Wisconsin Department of Transportation

**Proposal #08: 5685-00-05, Federal ID
 V of McFarland, Exchange Street
 Farwell St to Sleepy Hollow Road
 Loc Str
 Dane County**

This is Addendum No. 01, which provides for the following:

**ADDENDUM NO. 01
5685-00-05
December 8, 2023**

Addendum No. 01
 ID 5685-00-05
 Revised Sheet 11
 December 8, 2023

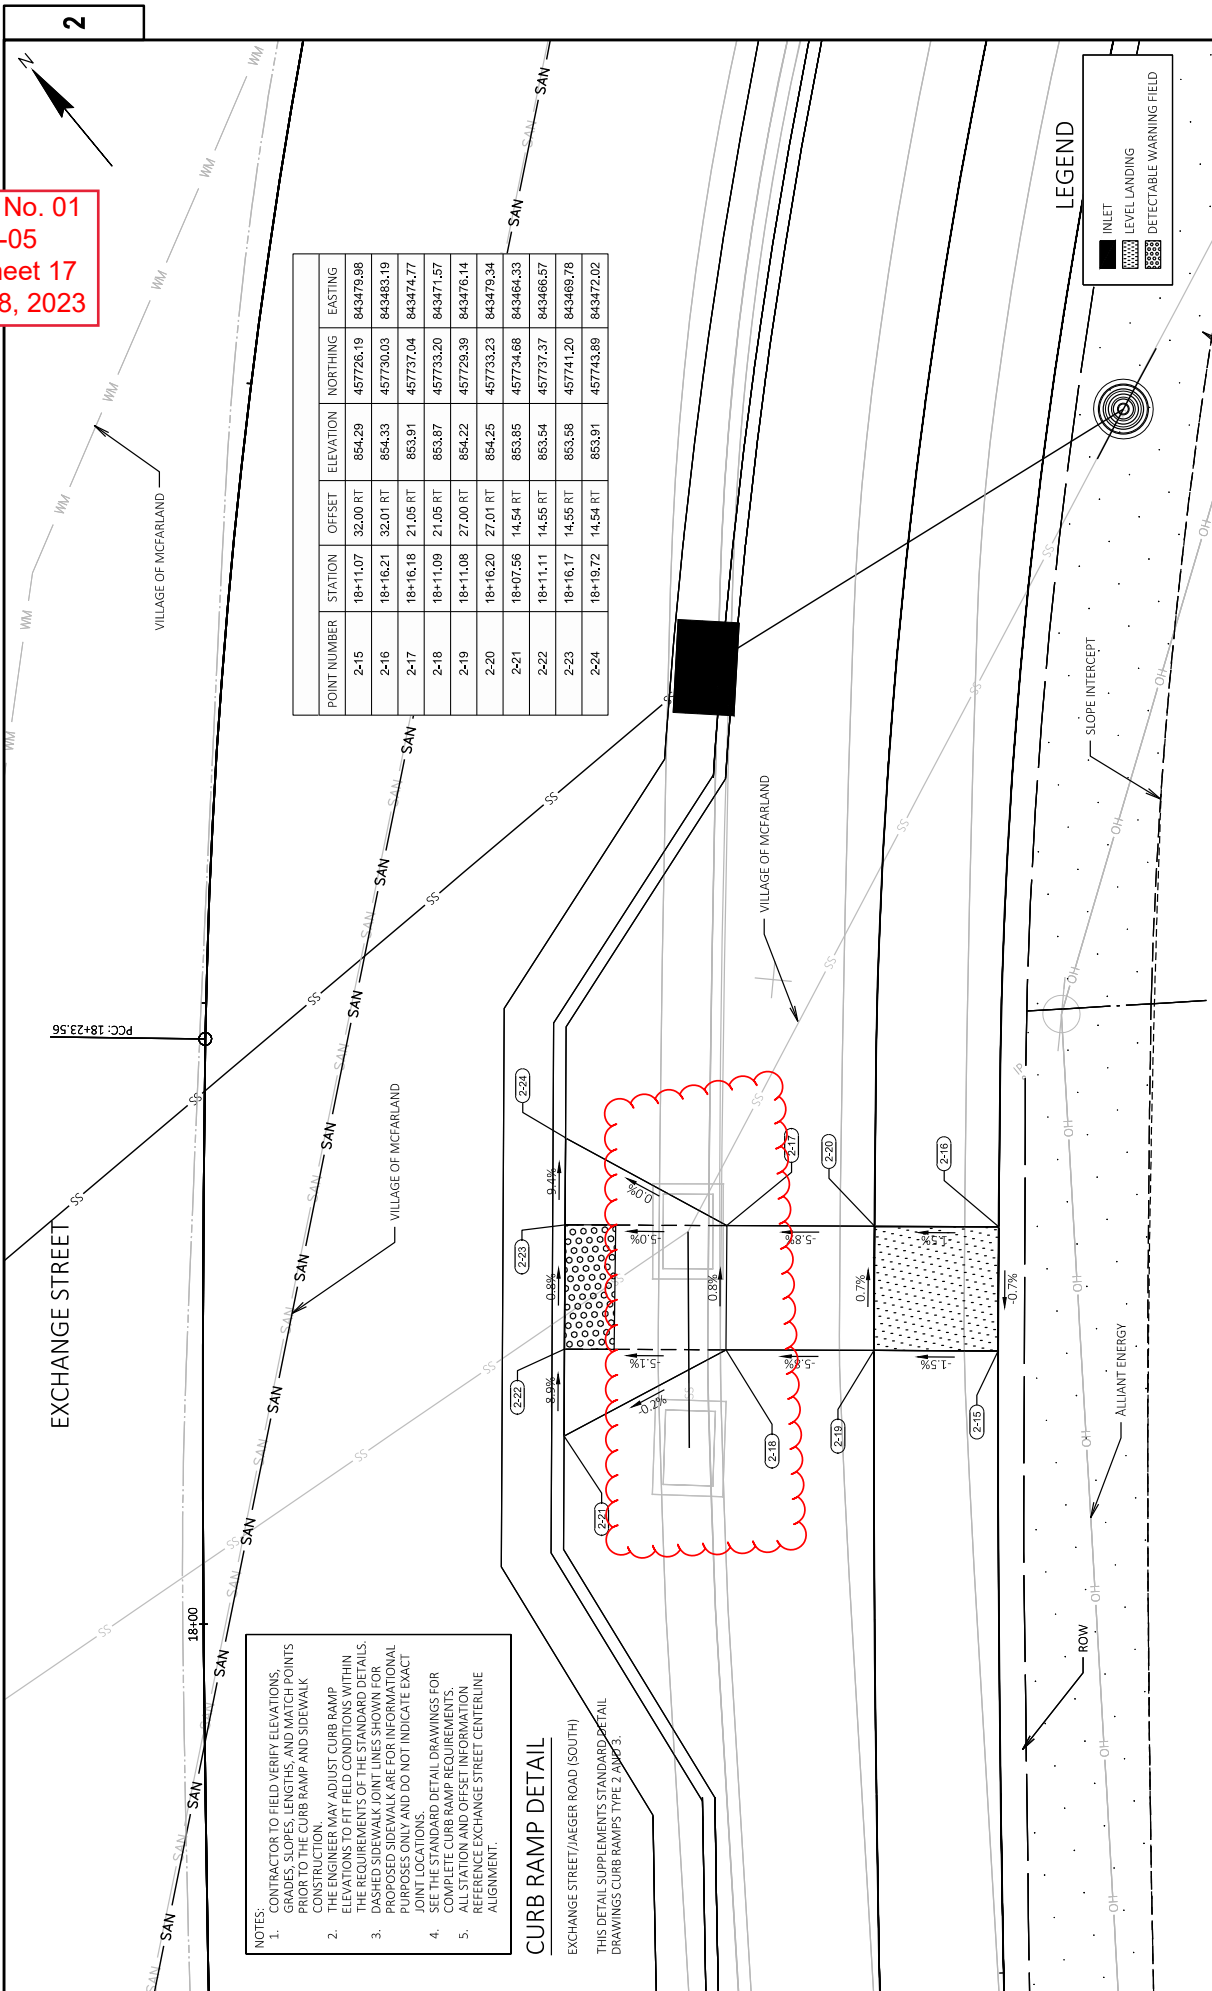
Revised Plan Sheets	
Plan Sheet	Plan Sheet Title (brief description of changes to sheet)
11	Intersection Details (Added details at northern project limits)
17	Curb Ramp Details- Exchange Street/Jaeger Road South (revised ex. Inlet depiction)
24	Curb Ramp Details- Exchange Street/Sure Avenue SE (revised connection to Sure sw)
71	Permanent Signing/Pavement Marking Plan (Added notes for SPV.0060.23)
75	Miscellaneous Quantities (revised to show quantity changes)
76	Miscellaneous Quantities (revised to show quantity changes)
77	Miscellaneous Quantities (revised to show quantity changes)
78	Miscellaneous Quantities (revised to show quantity changes)
80	Miscellaneous Quantities (revised to show quantity changes)
82	Miscellaneous Quantities (revised to show quantity changes)
89	Plan and Profile: Exchange Street (added silt fence)
90	Plan and Profile: Exchange Street (added silt fence, apron, car walk)
91	Plan and Profile: Exchange Street (added sidewalk side street connection, car walk)

Addendum No. 01
 ID 5685-00-05
 Revised Sheet 96
 December 8, 2023

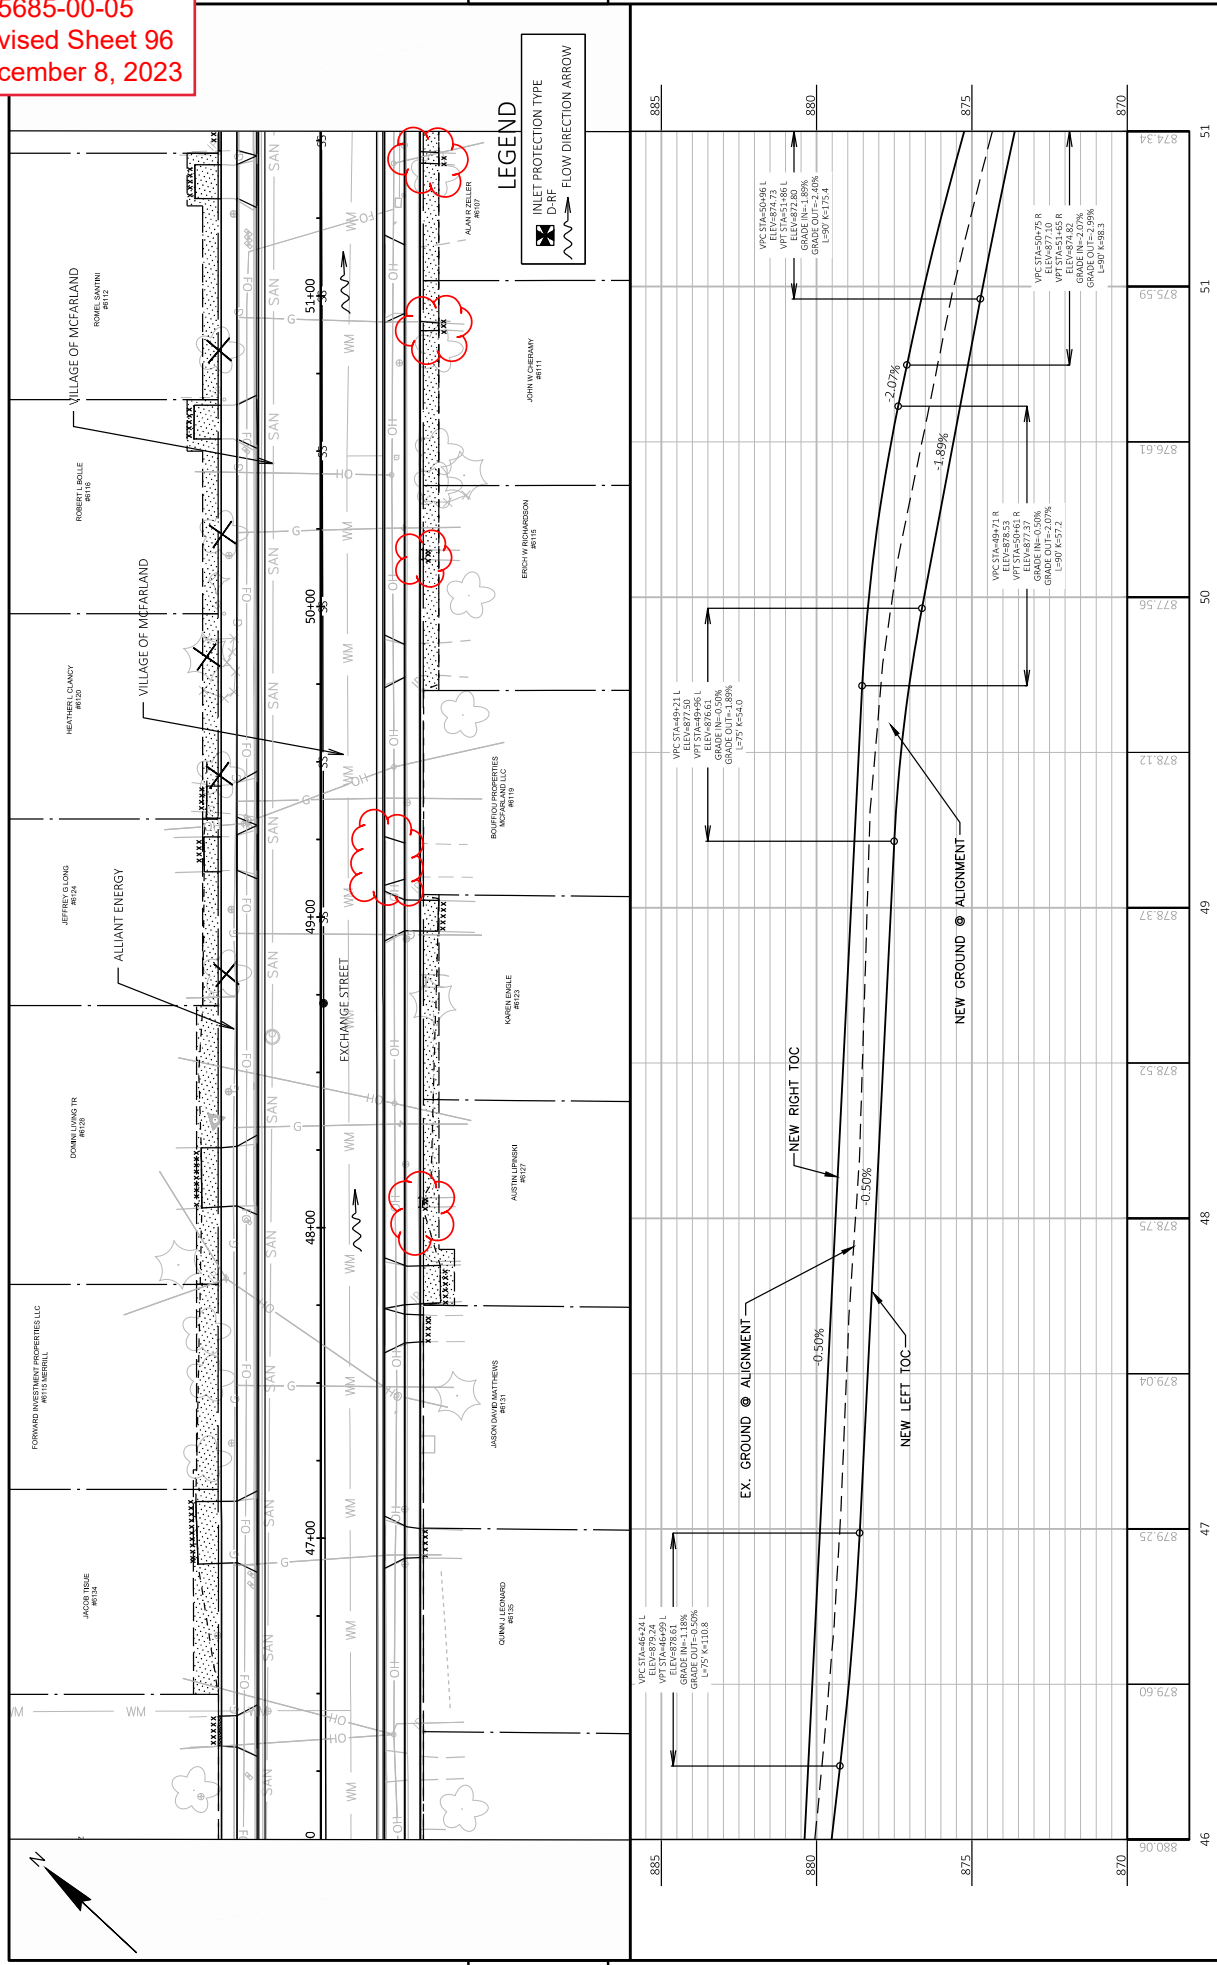
92	Plan and Profile: Exchange Street (added apron, sidewalk connection)
94	Plan and Profile: Exchange Street (added car walk, apron)
96	Plan and Profile: Exchange Street (added car walks, aprons)
97	Plan and Profile: Exchange Street (added car walks, aprons)
